WATERFRONT VILLAGE
 RAMSEY, MINNESOTA
PRELIMINARY LANDSCAPE PLAN
 FOR
CENTRA HOMES
 11460 ROBINSON DRIVE, COON RAPIDS, MN

DRAWN BY	BH
DATE	12/15/23
REVISIONS	
CAD FILE	24108-L
PROJECT NO.	24108
	L6.1

1 - Changemark note #01 AM

LANDSCAPE LAYOUT WEST:

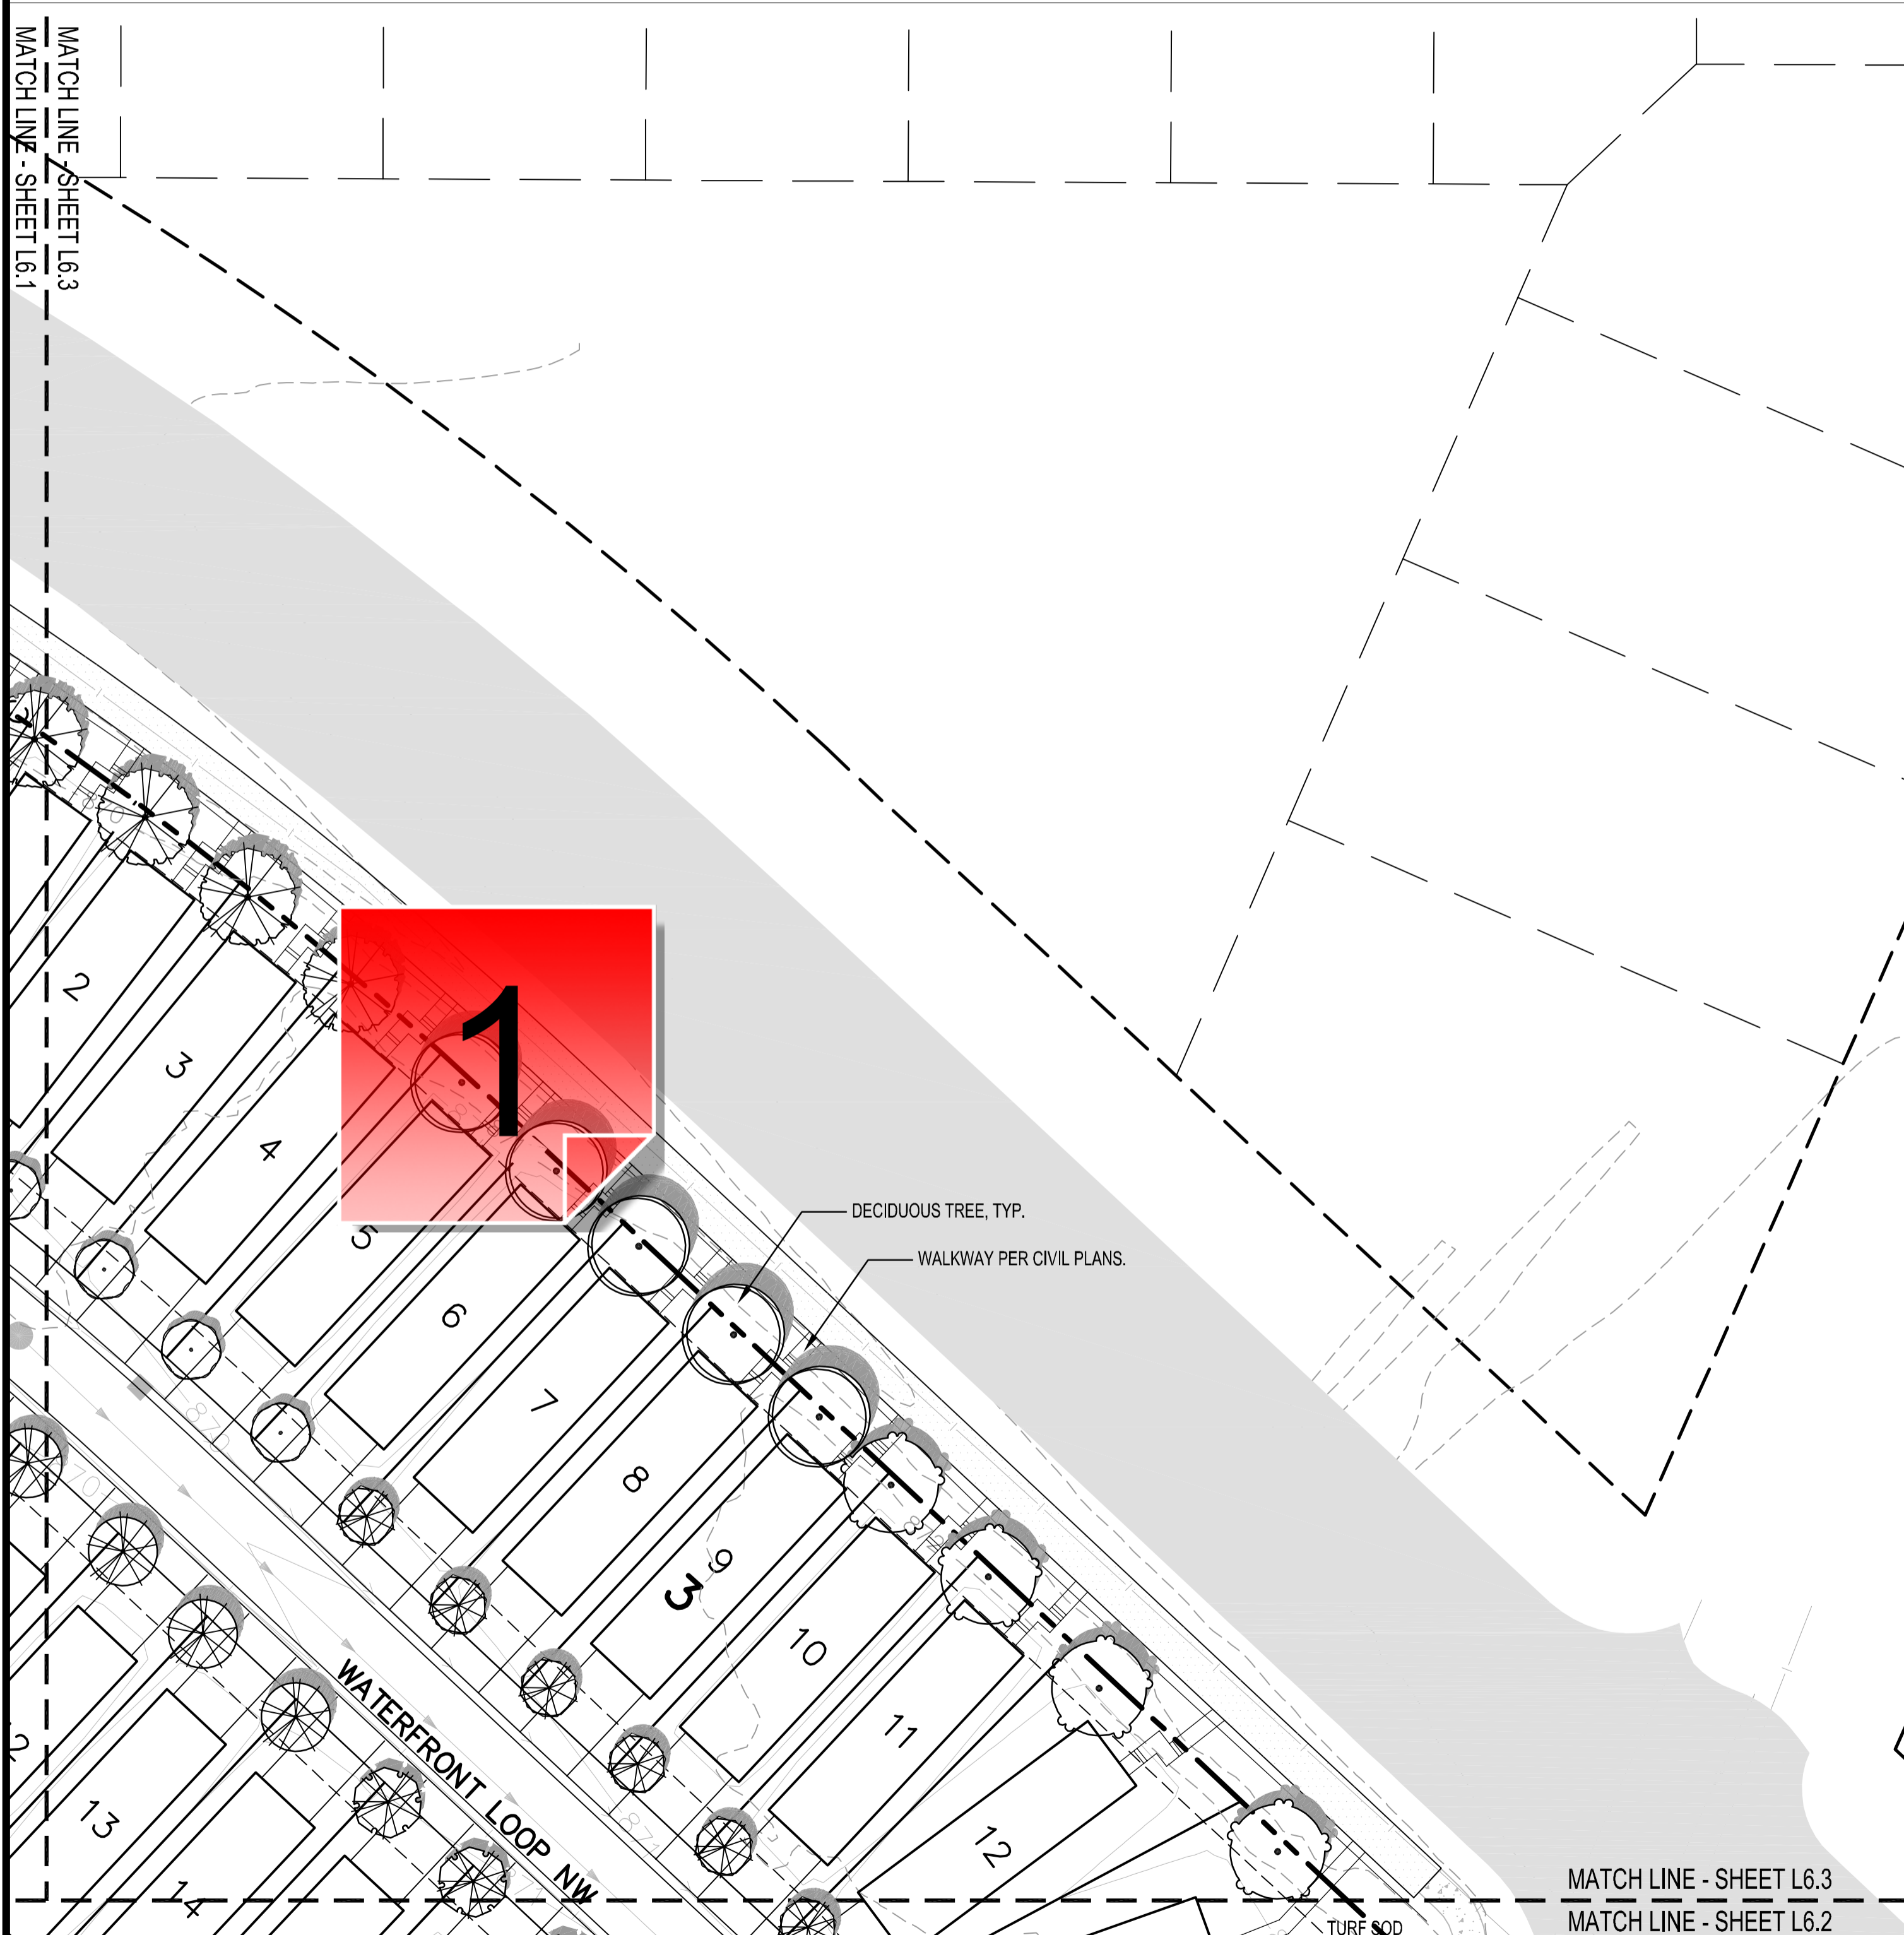
Clarify the need for stairs and jogs in each of the sidewalks that connect to Bunker Lake Blvd.

Four-sided architectural design will be needed on this unit.

To account for a prevalent northwest wind and traffic coming from Bunker Lake Blvd and Armstrong Blvd, please consider installing additional trees and shrubs here at the northwest corner of the development.

Please label what each symbol is in terms of species. With the legend on a separate page, it is not very convenient trying to see which symbol represents what species.

Is there sufficient growing space for these 2 trees? Especially once they reach mature size. Consider relocating them to behind the units.

LANDSCAPE LAYOUT EAST:

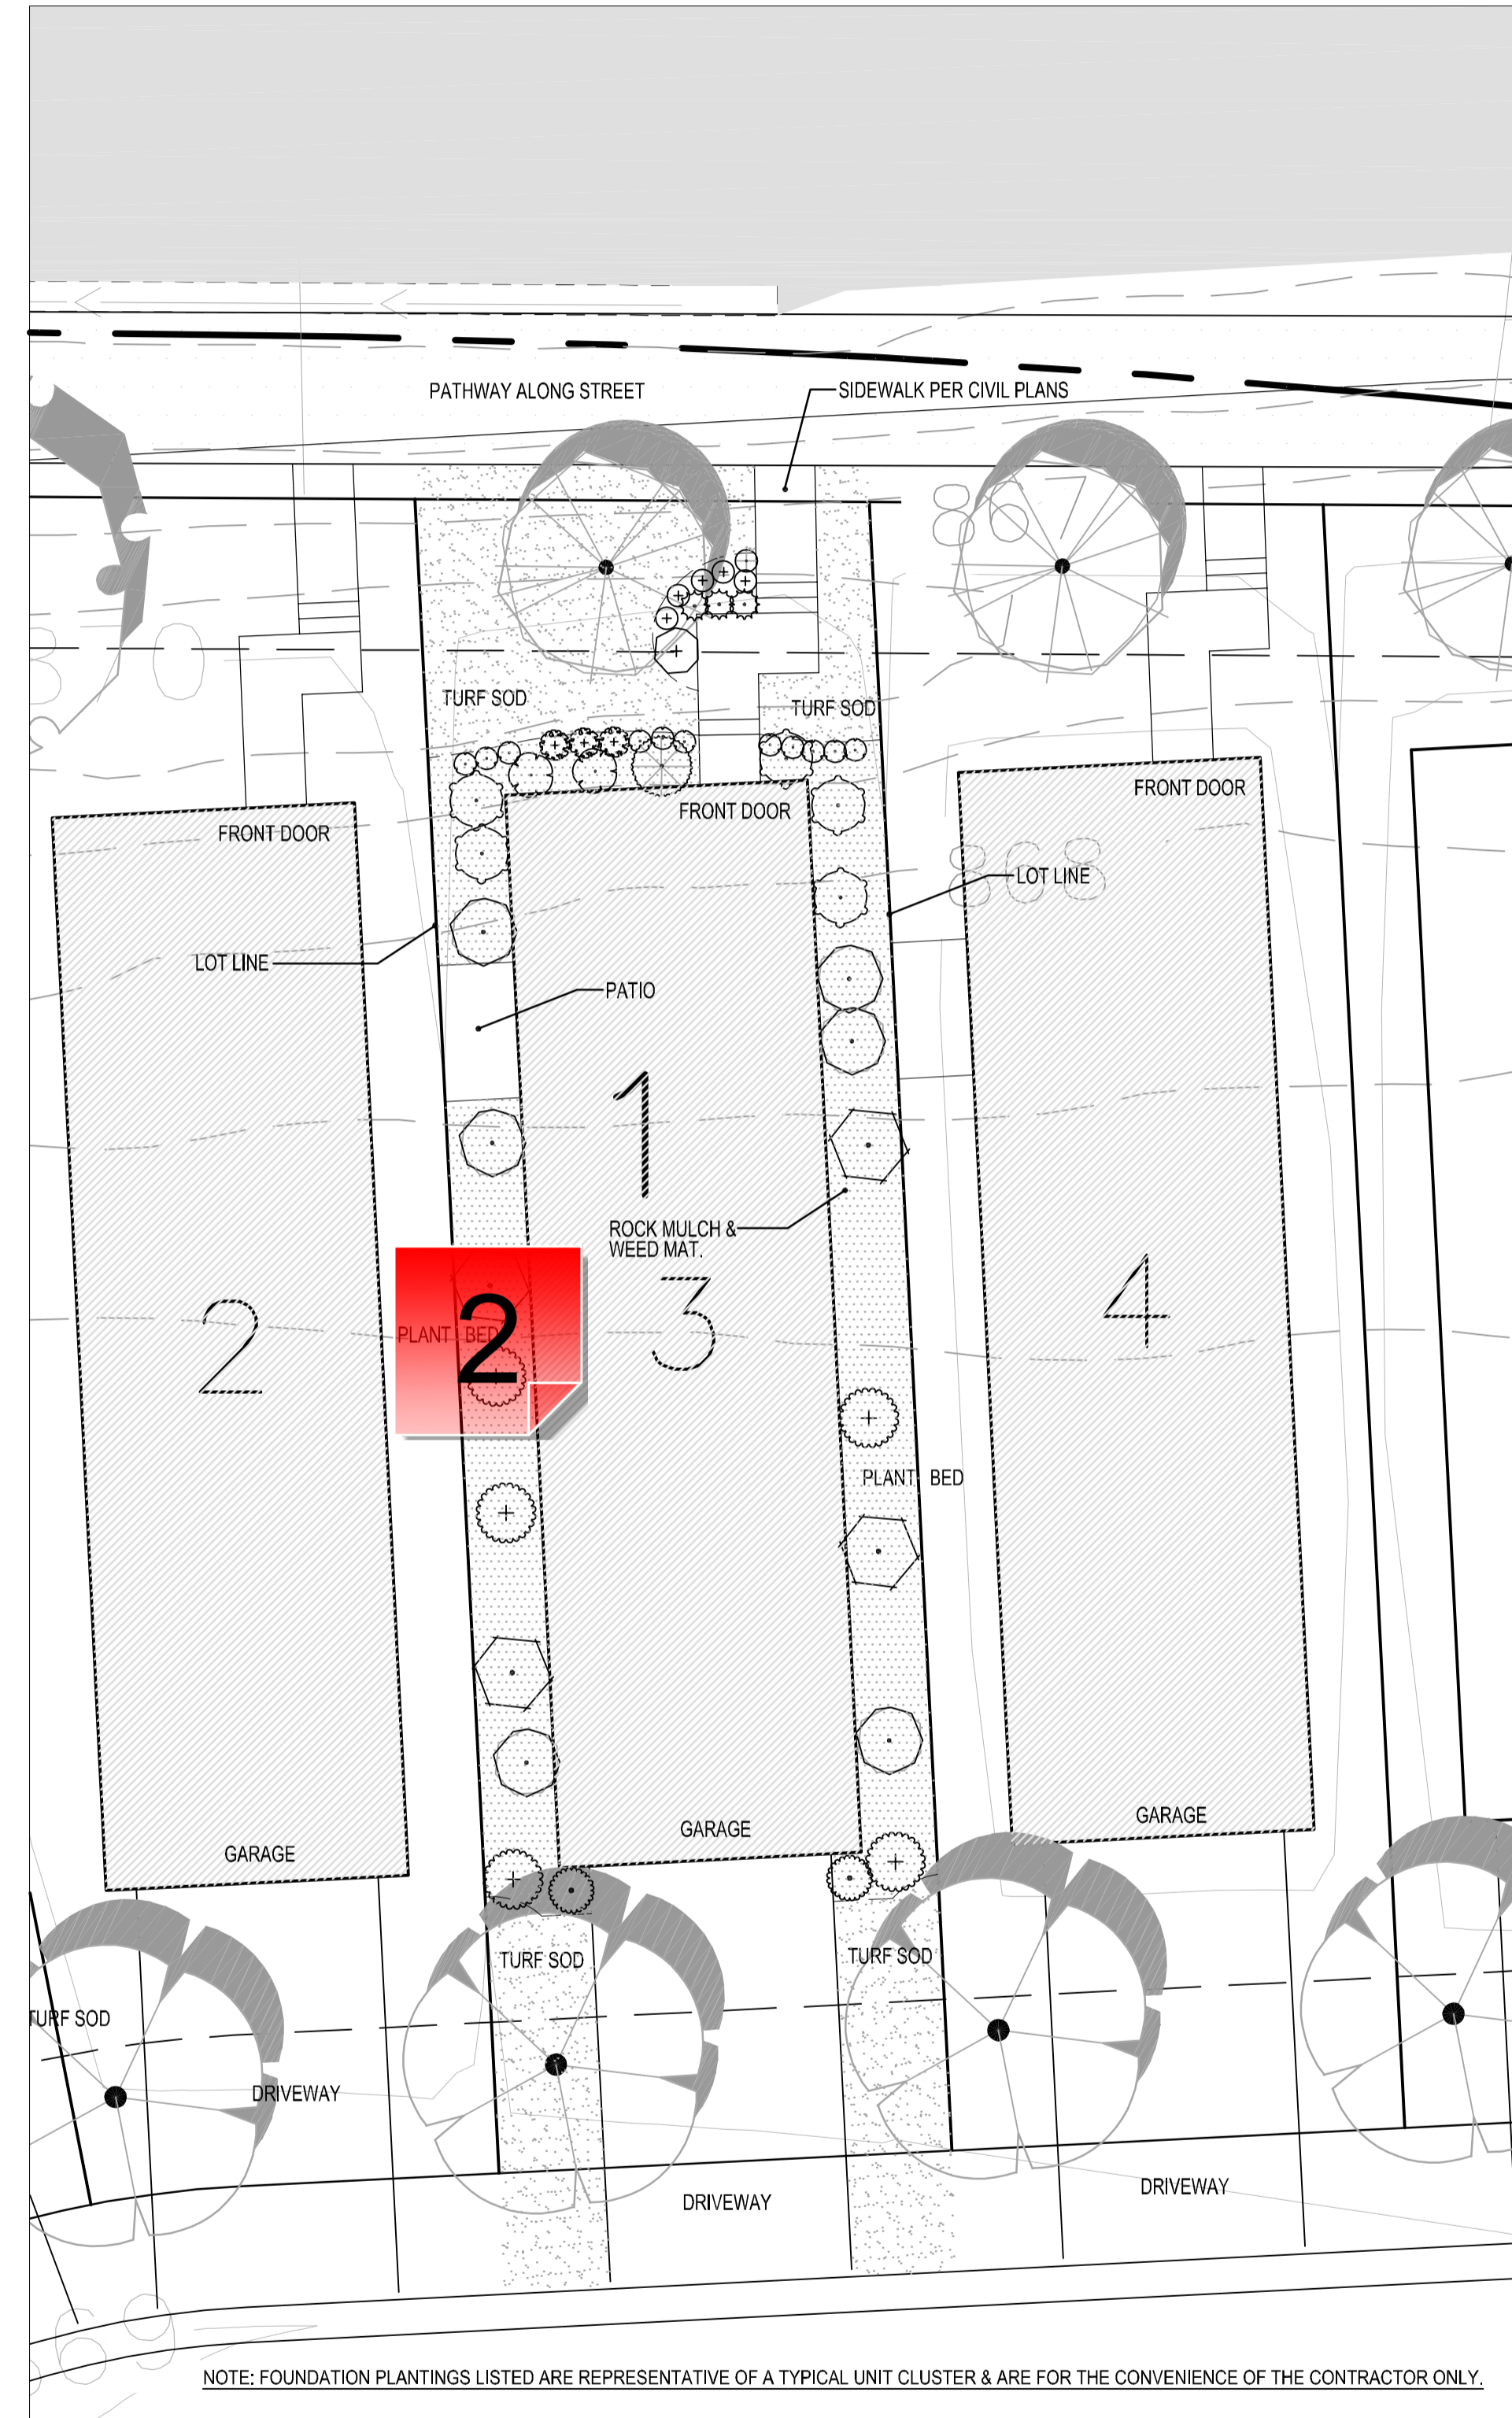
Four-sided architectural design will be needed on this lot.

Four-sided architectural design will be needed on this lot.

This row of trees should be shifted into the boulevard along Zeolite St.

When these trees are installed in the rear of these lots, make sure there is sufficient growing space so that at maturity, there is no conflict between trees and structures.

TYPICAL FOUNDATION PLANTING ENLARGEMENT:

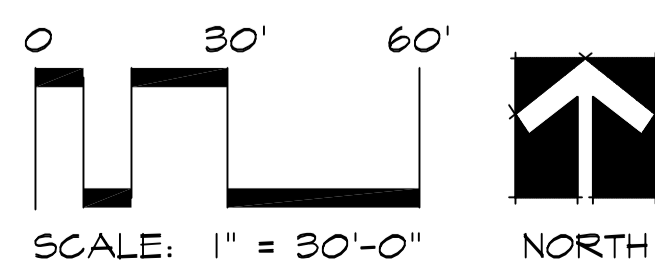
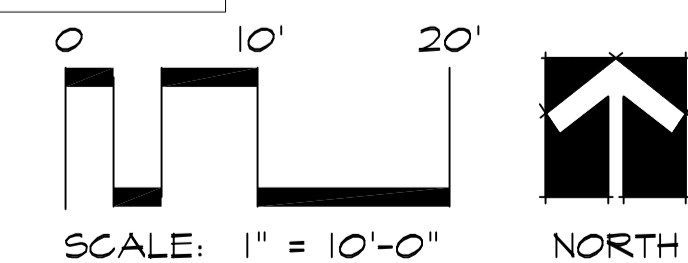
As noted on other plan sheets, clarify the need for stairs and jogs on each of the sidewalks that connect to Bunker Lake Blvd.

Another item regarding the landscaping plans is the proposal to install plant beds, rock mulch, and weed mats in between each house. The Cottages at the COR had proposed commercial turf sod in between houses, but it was ultimately built with rock beds and a few shrubs instead. Please provide clarity on the landscaping in between units.
